DOCUMENT 00914

ADDENDUM NUMBER 04

Project name: New Legislative Parking Garage
State Project Number: 81284-B
Project Address: 33 CAPITOL STREET
CONCORD, NH 03301

sheet no.
C2.01

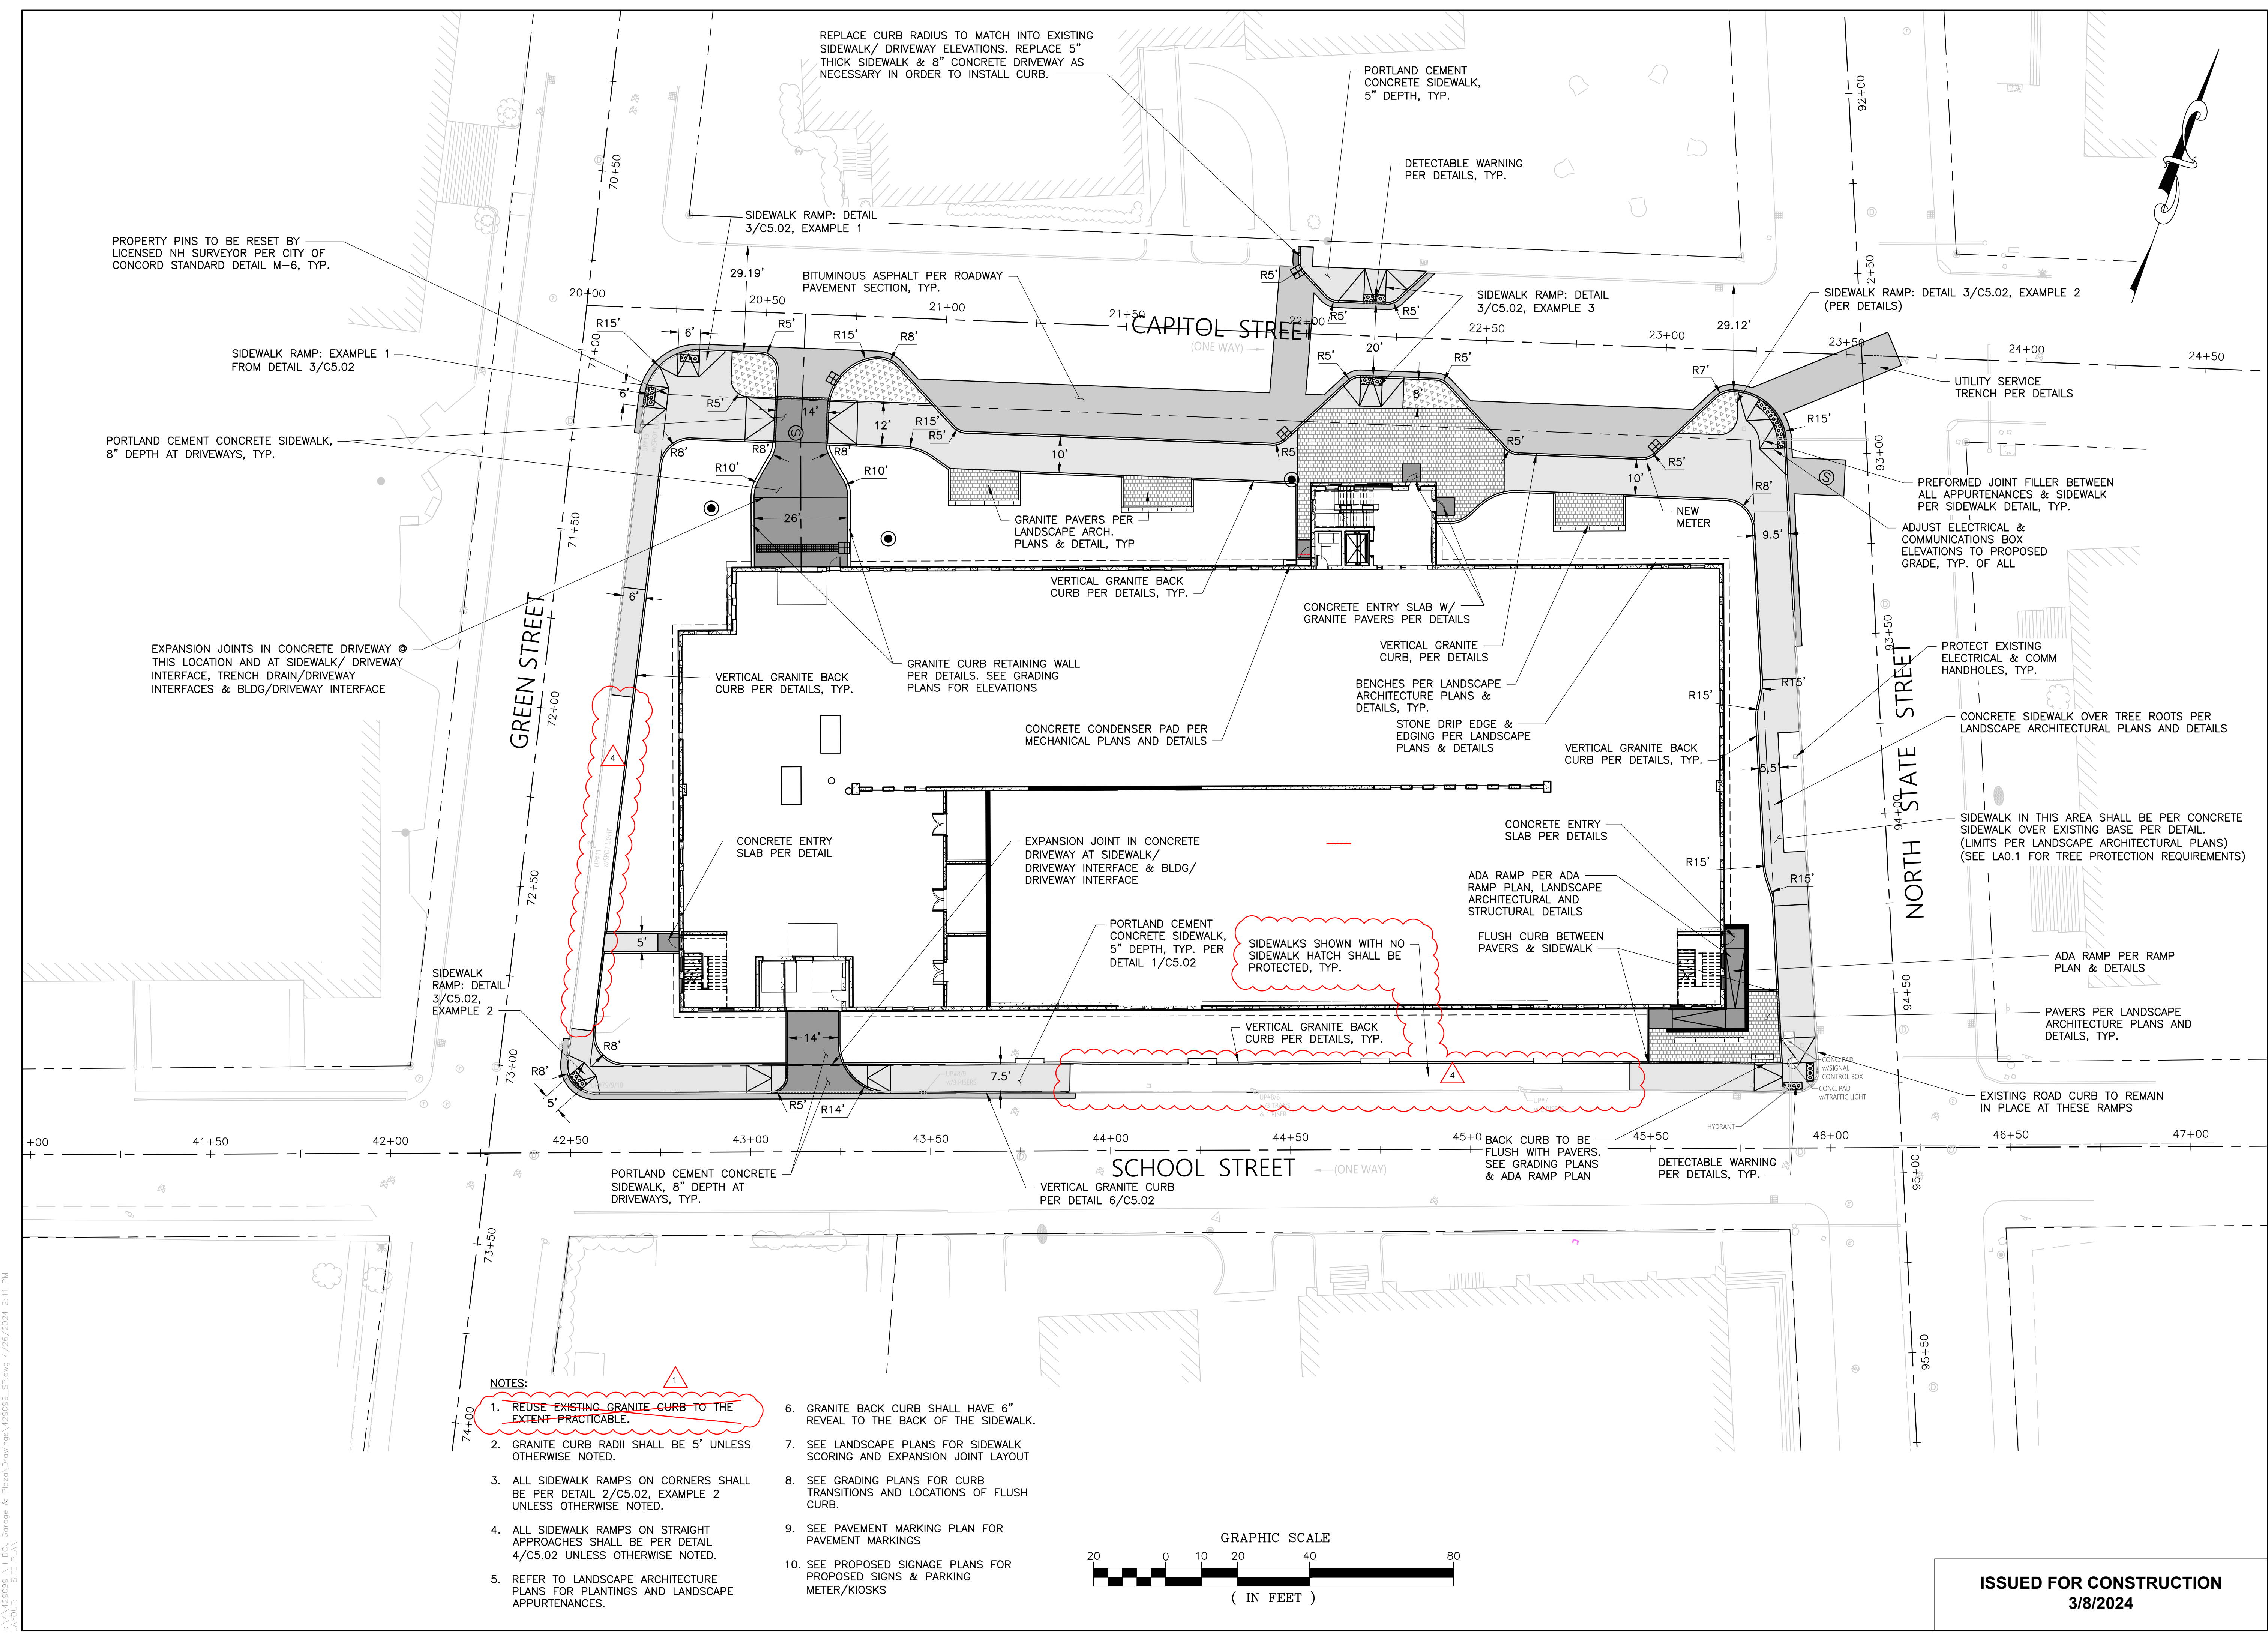
20. C2.01 Proposed Site Plan
 - A. Replace the drawing updated in Addendum 1 with the version re-issued in this Addendum; The purpose of this re-issue is to keep selected existing sidewalks and adjacent curbs along School Street and Green Street. This drawing indicates the sidewalk areas that are to be left in place and protected.

sheet no.
SK-003

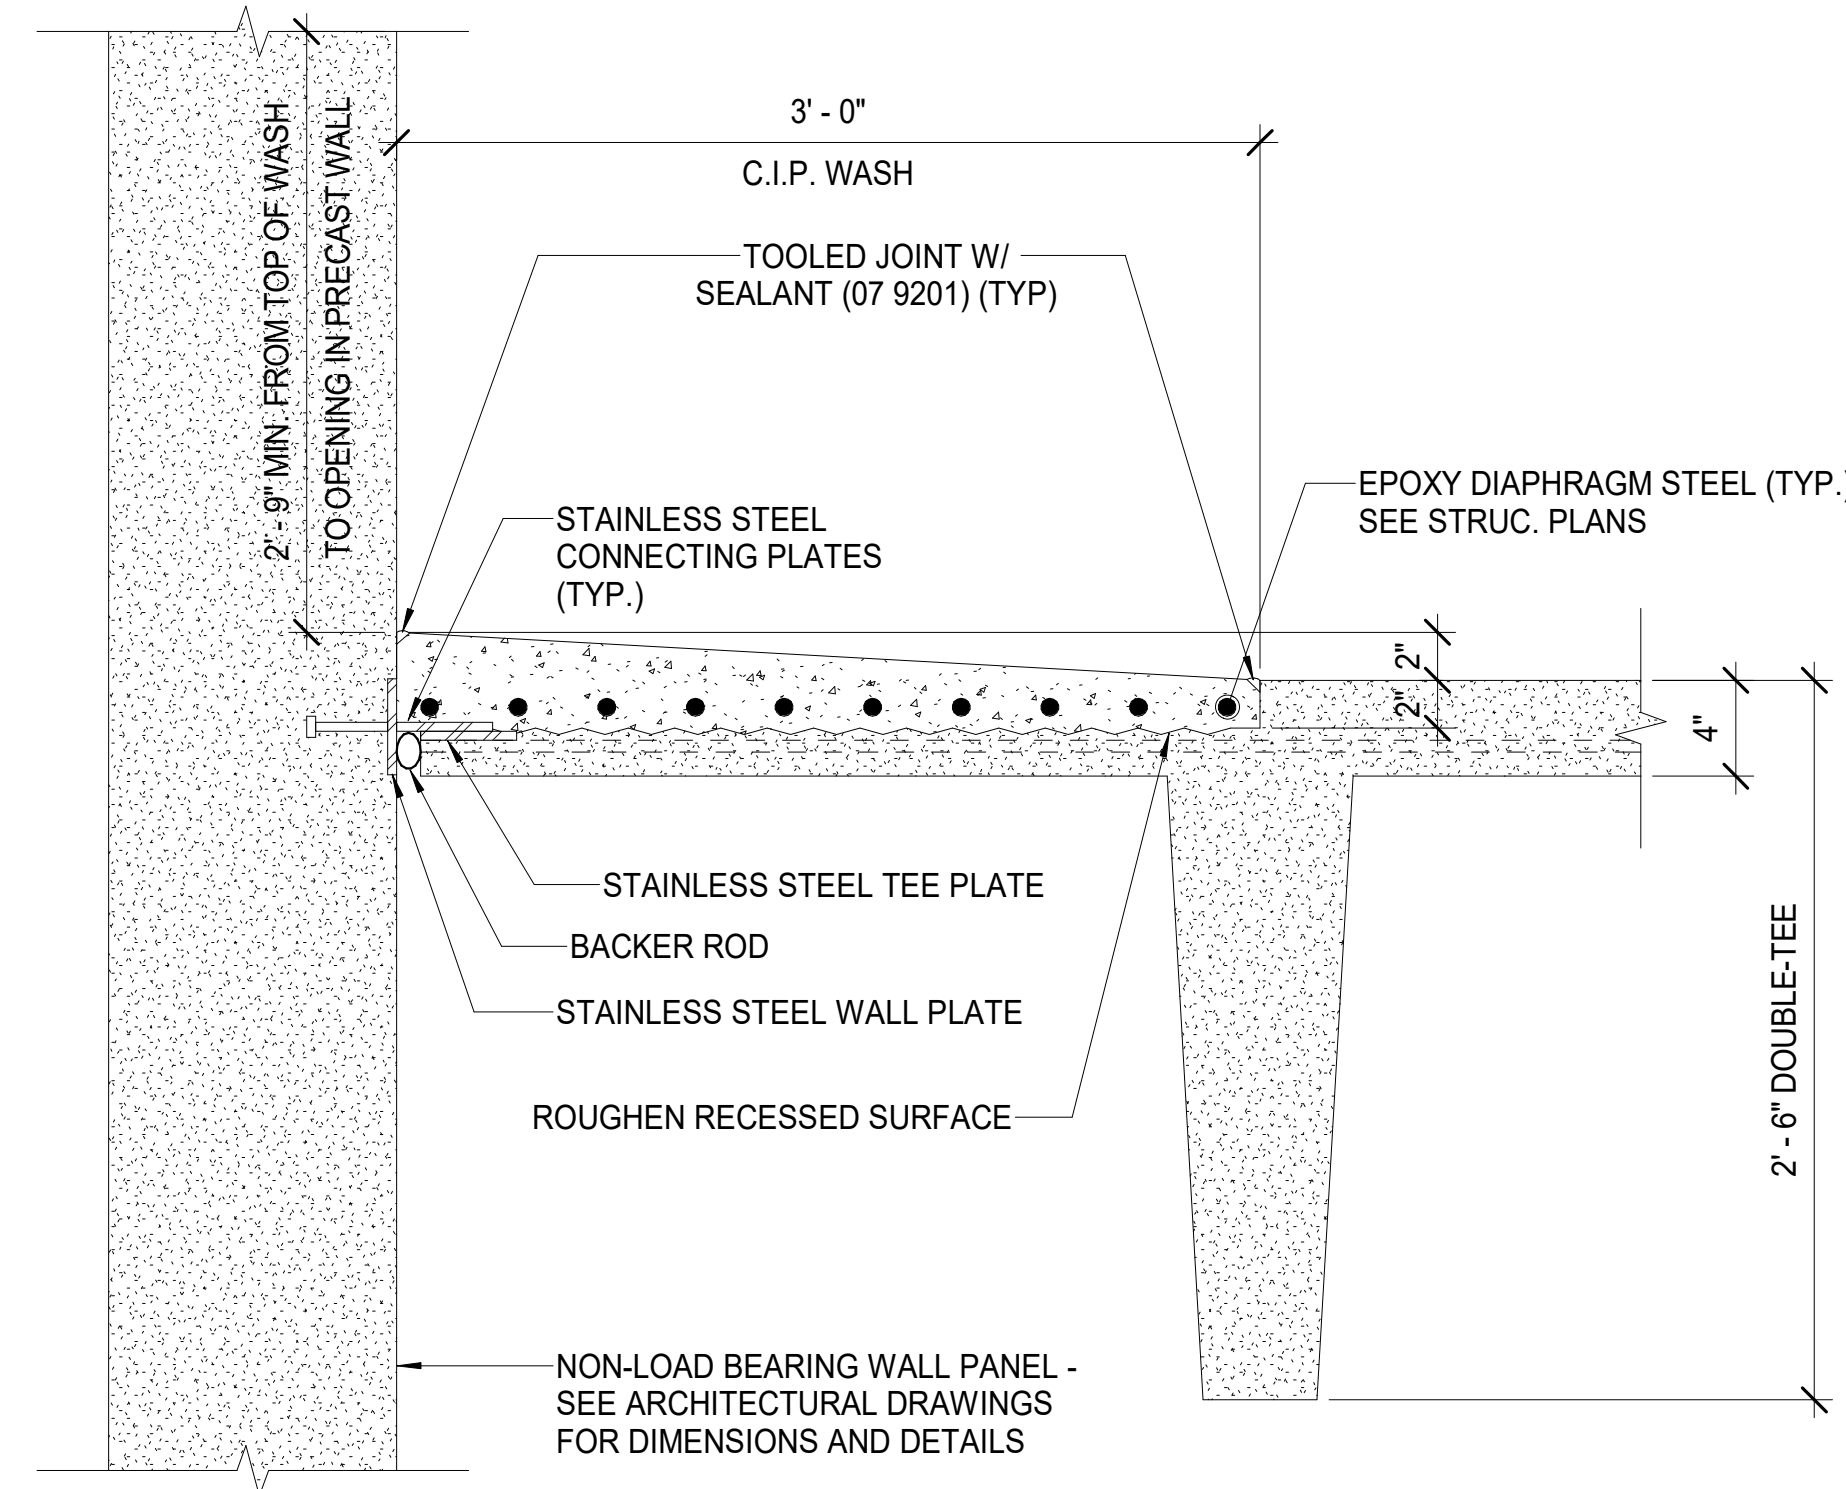
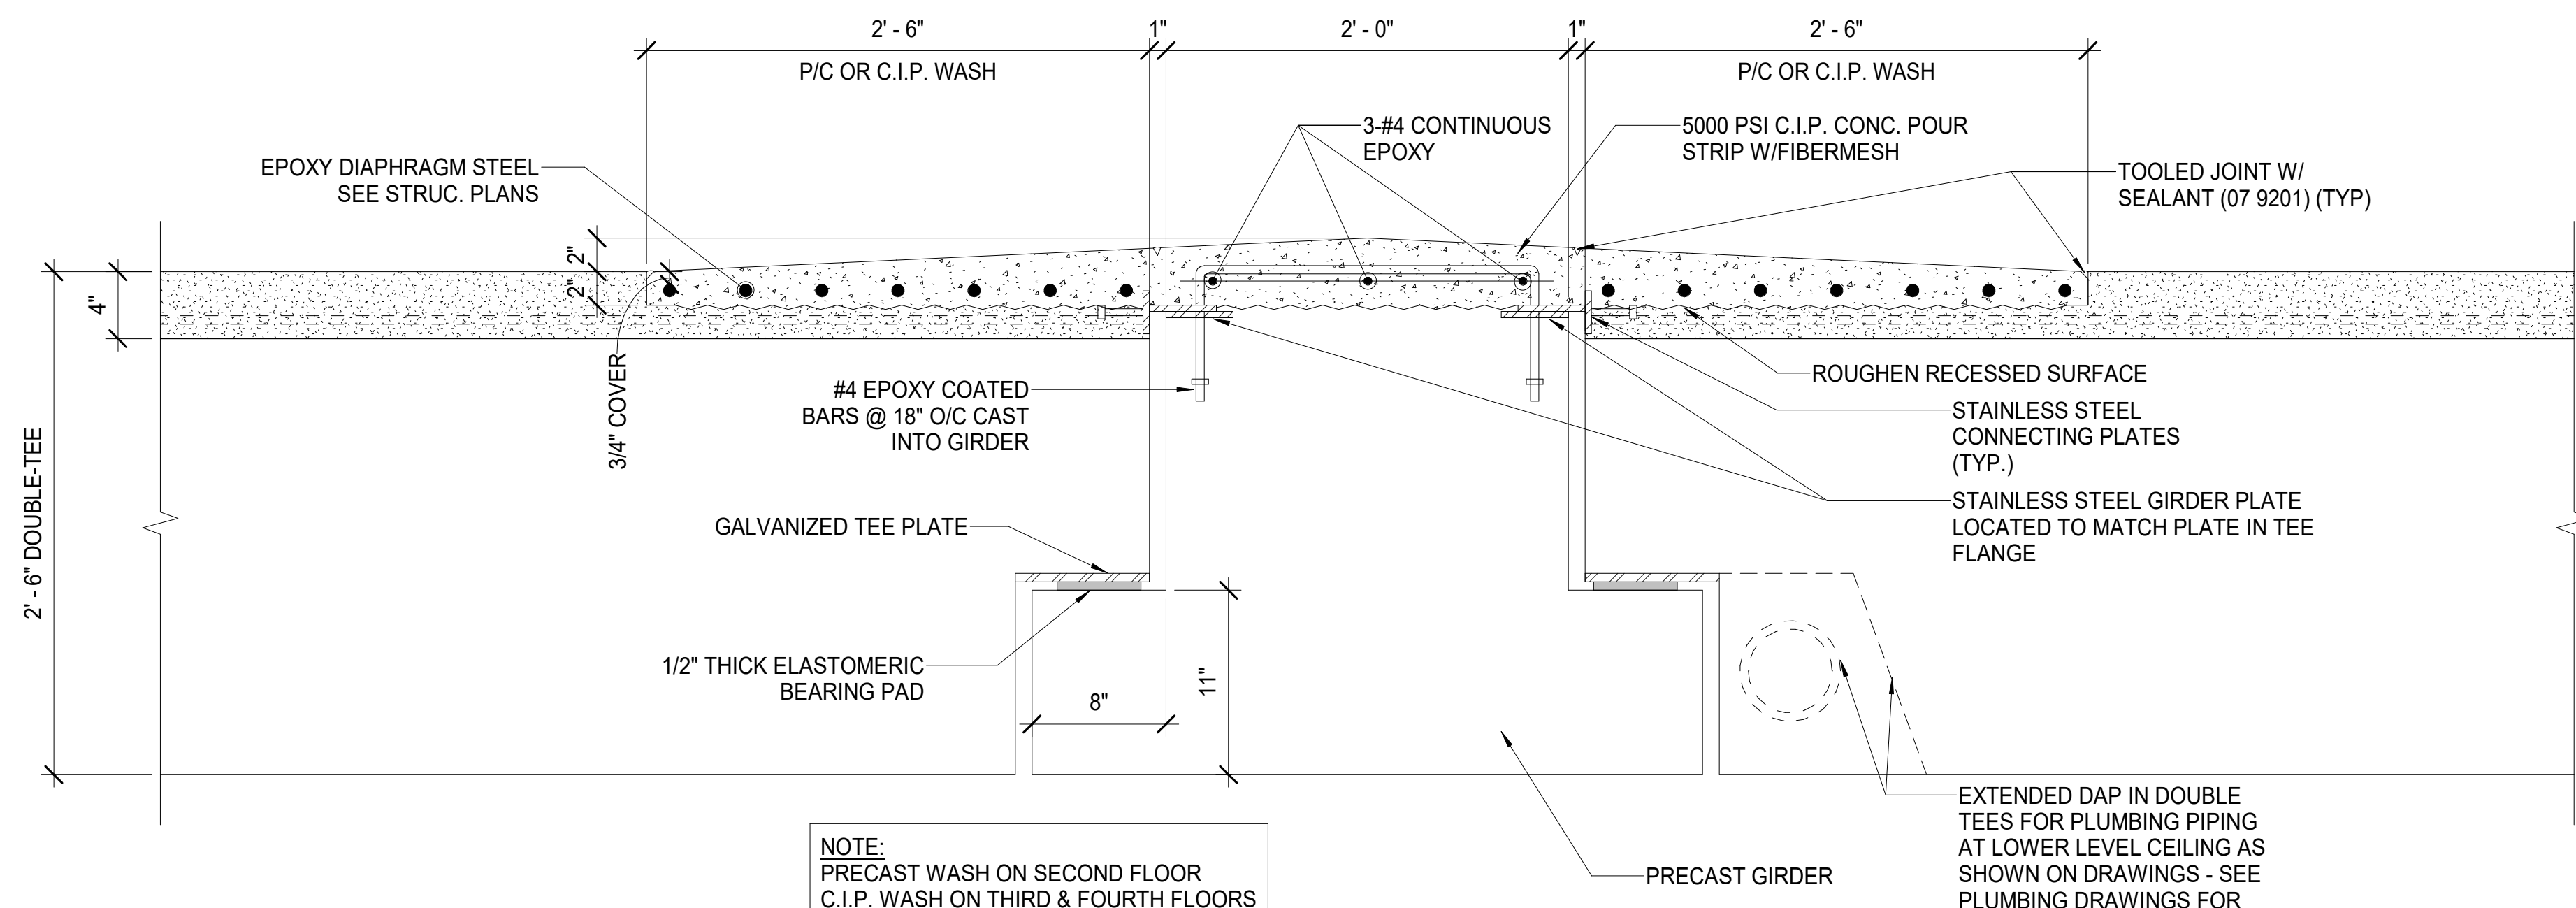
22. SK-003, SK-004, SK-005, SK-006 (as titled in the table at the beginning of this addendum).
 - A. Add SK-003, SK-004, SK-005, and SK-006 to the structural drawings.

1. In further response to Addendum 3 Question #6, these sketches are being added to the drawing set. They provide supplemental information about changing the precast washes to cast in place washes to better comply with Seismic Design Category C requirements. These sketches provide drawings and details showing the extent of cast in place washes and diaphragm steel.
